**NOTICE OF DECISION TO CONSENT TO CHANGE TO PROPOSAL DURING
ASSESSMENT**

Alkimos Seawater Desalination Plant
Assessment No. 2210

STATEMENT OF REASONS

CONSENT TO CHANGE PROPOSAL DURING ASSESSMENT

Figure 1a: Revised development envelope and indicative footprint

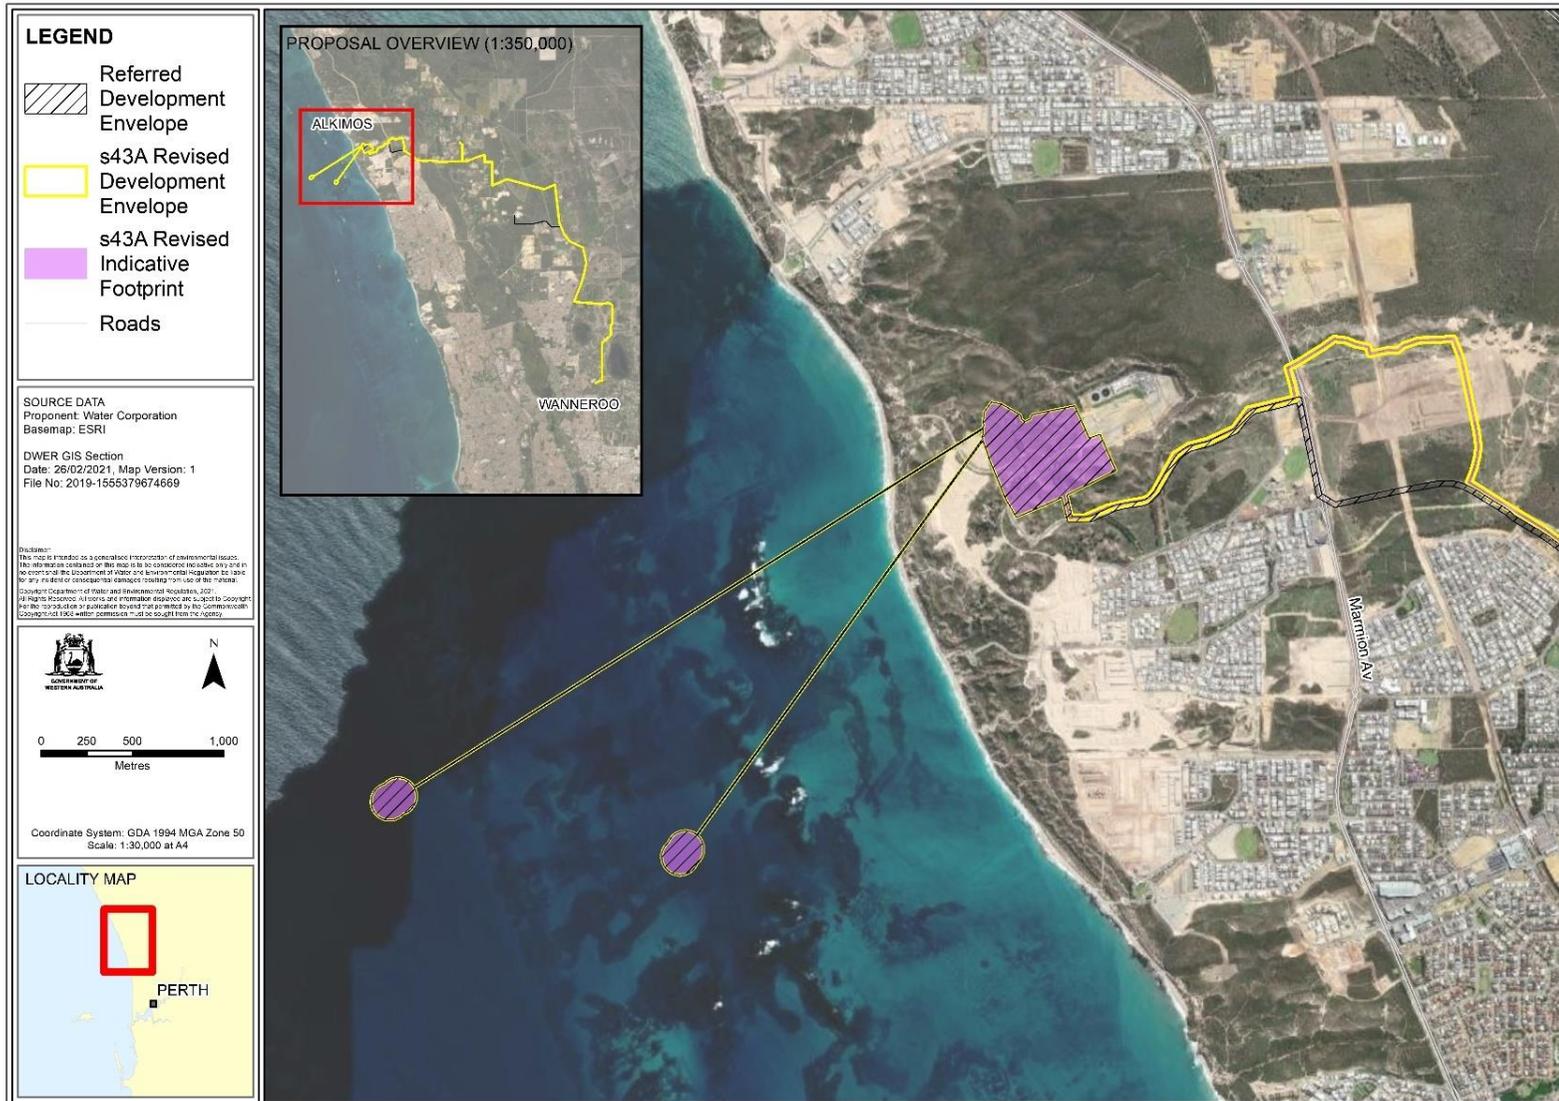
- 1) Reducing the overall extent of native vegetation to be cleared, refinement of the indicative disturbance footprint, and reducing the overall extent of the development envelope.
- 2) Amendments to the key characteristics of the proposal

The key changes to the development envelope are the removal of the Nowergup tank farm pipeline spur and a realignment of 2 kms of pipeline near the proposed SDP (Figures 1a and 1b). Clarification of the construction requirements for the pipeline have also resulted in changes to the development envelope. Flora and

The pipeline spur was removed as this component is not required. It may form part of a separate proposal as part of the Nowergup tank farm, if the infrastructure is required in the future. The realignment of the pipeline was required to allow a portion of the pipeline to be installed within a common trench and to reduce congestion of utilities along Romeo Road. Changes to the construction requirements were to provide for a wider footprint for trenching and installation of the pipeline.

The changes will result in an overall decrease in the extent of the development envelope from 155.7 ha to 140.5 ha, which in turn reduces the overall extent of native vegetation to be cleared, from 46.5 ha to 44.5 ha (2 ha decrease).
